State of New Mexico  
Energy, Minerals and Natural Resources

Form C-103  
June 19, 2008

SUNDRY NOTICES AND REPORTS ON WELLS  
(DO NOT USE THIS FORM FOR PROPOSALS TO DRILL OR TO DEEPEN OR PLUG BACK TO A  
DIFFERENT RESERVOIR. USE "APPLICATION FOR PERMIT" (FORM C-101) FOR SUCH  
PROPOSALS.)

After formation evaluation, Energen Resources would like to make the following changes to the Many Canyons 24-03 8 #4H:

Plan: APD Plan - Revised

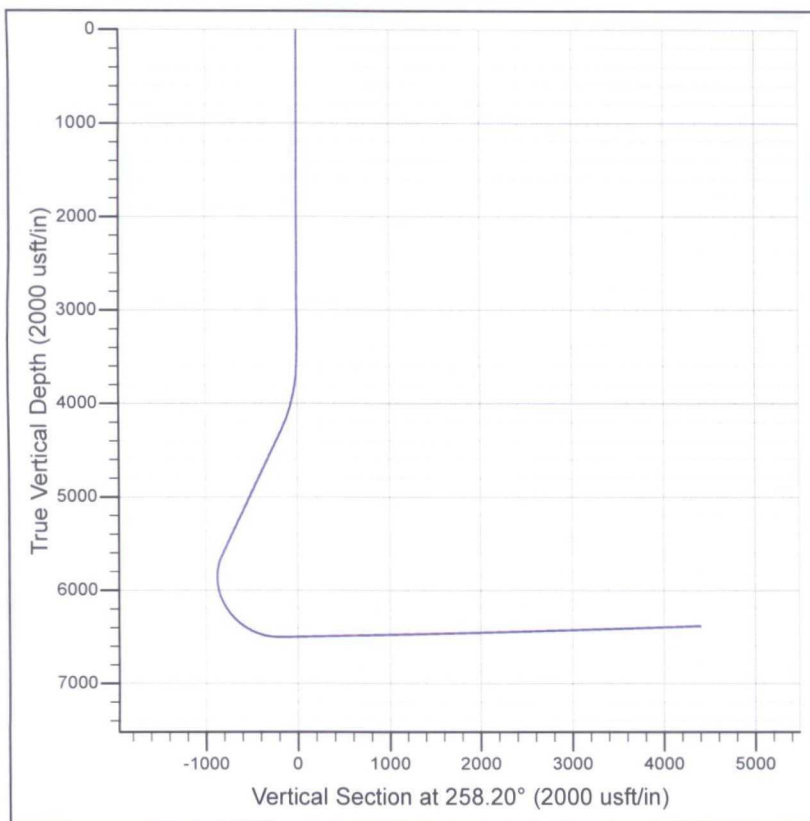
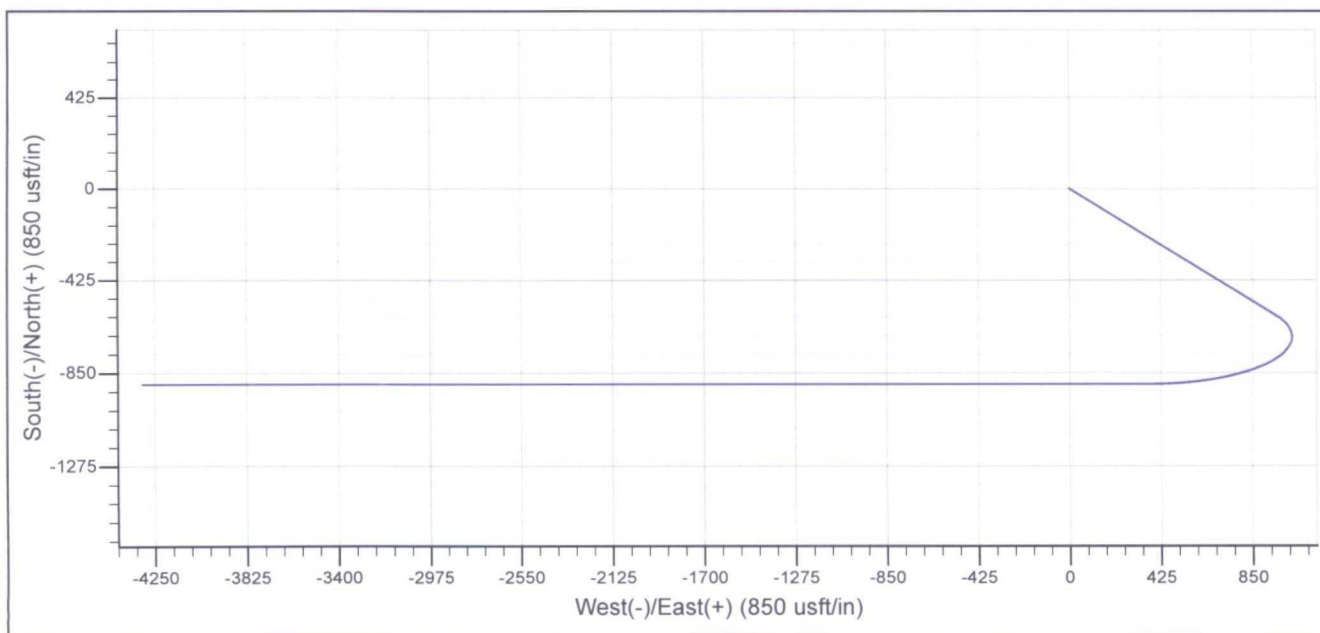
Change the set depth of the 7" second intermediate to 6,505' (TVD); 7,265' (MD) and increase the tail cement to 185 sks.

Change the set depth of the 4 1/2" liner to 6,505' - 6,389' (TVD); 7,065' - 11,954' (MD) and increase the cement to 510 sks. The take points for production will remain at 330 fsl, 330 fwl and 330 fsl, 330 fel.

Attached is a revised drilling operations plan and directional plan depicting this change.
